Date: 30th September 2022
Our Ref: YM JN 20173

RE: CLARIFICATION OF FURTHER INFORMATION RESPONSE IN RESPECT OF A PLANNING APPLICATION FOR A PROPOSED PHASE 3 RESIDENTIAL DEVELOPMENT AT TUBBER LANE, ADAMSTOWN SDZ, ADAMSTOWN, LUCAN, CO DUBLIN

REG. REF.: SDZ21A/0023

Figure 2.1: Location of TAUs and additional Universal Type Dwelling (No.400)

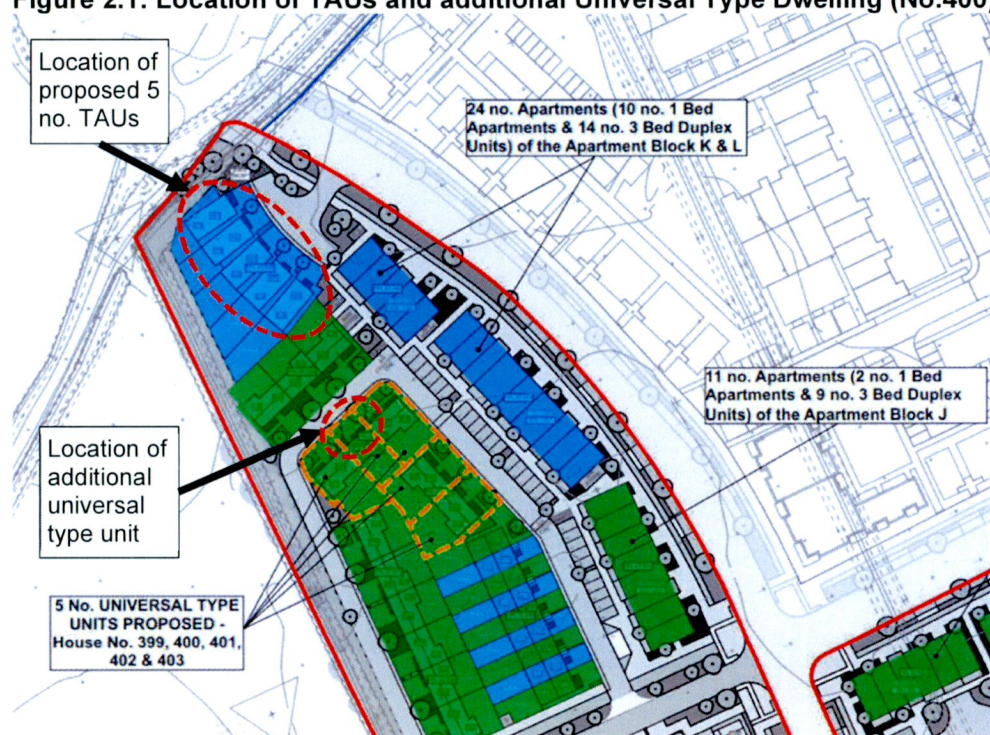
“At Further Information stage, the applicant was requested to make contact with the Housing Department regarding Part V. The Housing Department has raised concerns regarding the submission with regards TAU obligations. It is noted that 6 units are proposed, however, the preference is for detached units. The applicant is requested to engage further with the SDCC Housing Department and address this.

The applicant is requested to provide an updated schedule of accommodation, reflecting any changes.”

- 2.3 In response to the above, please refer to the Part V drawing prepared by Davey & Smith Architects and the correspondence with Elaine Leech of South Dublin County Council's Housing Department attached at Appendix 2 of this letter.
- 2.4 In summary, the applicant engaged with the Housing Department and agreed that the Part V provision on site would include 5 no. detached Traveller Accommodation Units (TAUs) (nos. 449-453 – Type K) and 1 no. universal type unit (no.400 – Type J) to replace the previously proposed 6 no. terraced TAUs. Therefore, there is no

reduction in the total number of Part V units proposed under the revised scheme (91 no. Part V units total).

- 2.5 The 5 no. TAUs have been subject to a full redesign. The revised units are fully detached, dual aspect units with a floor area of 122.5 sq.m. The revised TAUs have been reorientated to face the Celbridge Link Road. The locations and layout of all proposed Part V units are identified on the Part V drawing prepared by Davey & Smith Architects, an extract from which, with the 5 no. TAU units and the additional universal type unit identified, is included at Figure 2.1 below. The final specification of the units will be subject to a future agreement between the applicant and the Housing Department following a grant of permission.
- 2.6 An updated schedule of accommodation, prepared by Davey & Smith Architects, is included with this submission.

Figure 2.4: Revised bin stores and collections zones – Blocks A, B, C, D and I

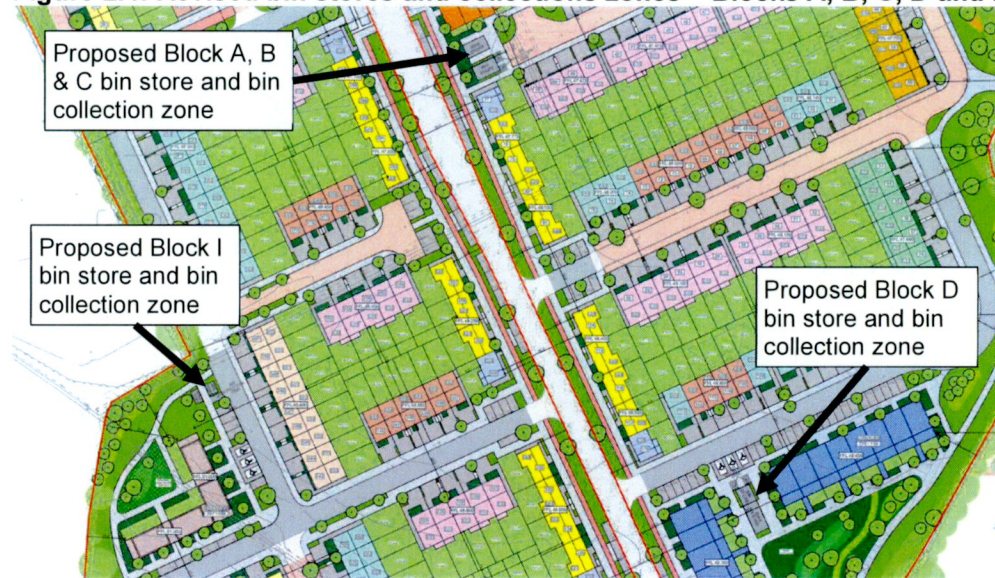
- (a) *The applicant shall submit information which confirms that the road cross sections confirm to the SDZ guidelines for road types, particularly when perpendicular parking is proposed, there must be a minimum of 6.0m reversing space behind or an increased parking bay width.*
- (b) *The applicant has submitted details of the refuse vehicle Autotrack movements. The kerb collection points for the apartment blocks are also identified on the plans, as shown in Figure 11. The location of large refuse containers on the public footpath or road carriage way for collection must be avoided, particularly if 1100Ltr containers are in use. The applicant shall identify collection points for the apartment blocks off the public areas or road carriageway"*

- 2.25 With respect to point 3(b) above, which relates to the refuse vehicle movements and waste collection locations, we refer to the revised Site Layout Plan which includes revisions to the proposed communal bin stores and dedicated bin collection points for the apartment blocks. The revised bin store locations and bin collection areas for Blocks J, K and L are shown in the site plan extract presented at Figure 2.3 above. The revised bin store locations and bin collection areas for Blocks A, B, C, D and I, and F, G and H, are set out at Figures 2.4 and 2.5, respectively.

- 2.26 The bin storage and bin collection areas were revised following consultation with Byrne Environmental and, as shown in the site plan extracts, the revised locations provide for both easily accessible refuse storage for residents and the efficient collection of bulk bins.

- 2.27 As set out in the enclosed POGA Cover Letter, and the Byrne Environmental Waste Collection Strategy, the revised proposal for refuse storage and collection is in accordance with the waste management policies and development standards set out in the South Dublin County Development Plan 2022 – 2028, and the design of the communal bin stores and the bin collection points will ensure that the bin collection process is fast and efficient and that bins shall not impede pedestrians or road users within the development.

Figure 2.6: POGA Drainage Layout (extract) identifying existing ditch and hedgerow to be retained and location of proposed swale

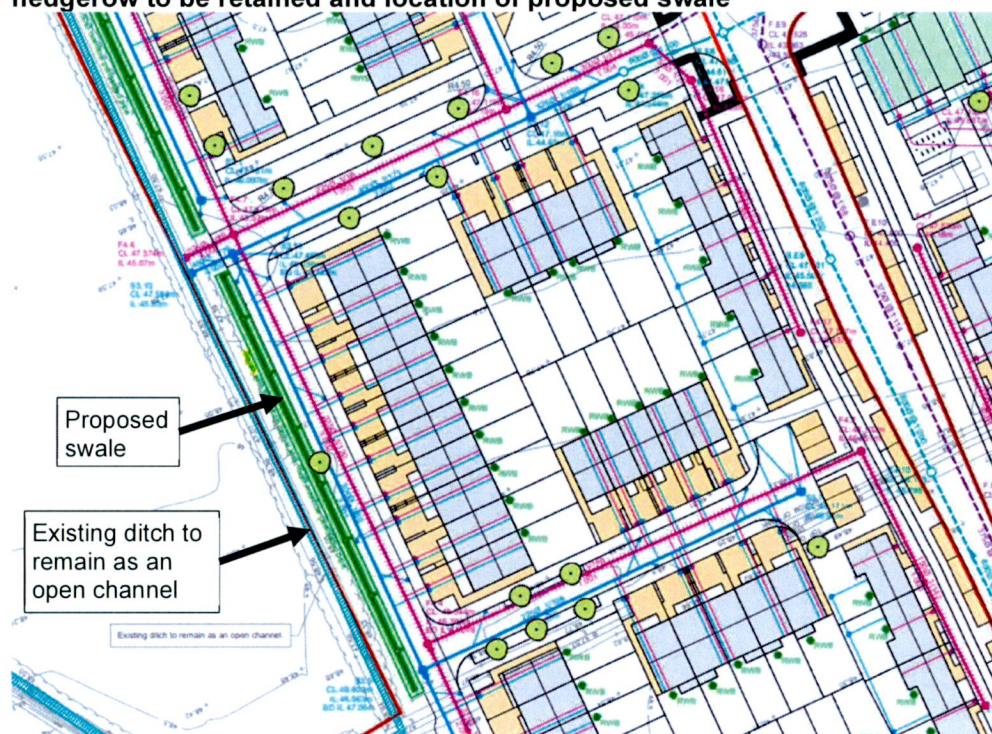
- (a) *The applicant is requested to clarify the following and update the relevant plans.*
- *There are still large areas without street trees. Trees in front driveways are not street trees. Street tree plan is still to be agreed. Street tree plans should identify Suds tree pits.*
 - *Suds design is still lacking in detail. Please consult SDCC Suds guidance document and show treatment train, demonstrate amenity and biodiversity value of proposals.*
 - *Infilling of ditches is identified on ecological report as a threat to bats. However, despite this being flagged this scheme still proposes infilling of*

ditches to construct a swale. The swale can be constructed outside the ditch in the space previously occupied by the cycle lane.

- 2.33 In respect to the infilling of ditches, we refer to the POGA CFI Response, which clarifies that the drainage ditch is not being altered in any way (i.e. it not proposed to infill the drainage ditch to construct a swale), and that the swale is a separate SuDS element that runs parallel with the road, within the area previously occupied by the cycle track, as shown in the extract from the POGA Drainage Layout presented at Figure 2.6. We also refer to the RMDA CFI Response which demonstrates that the existing hedgerow to the western site boundary is to be retained.
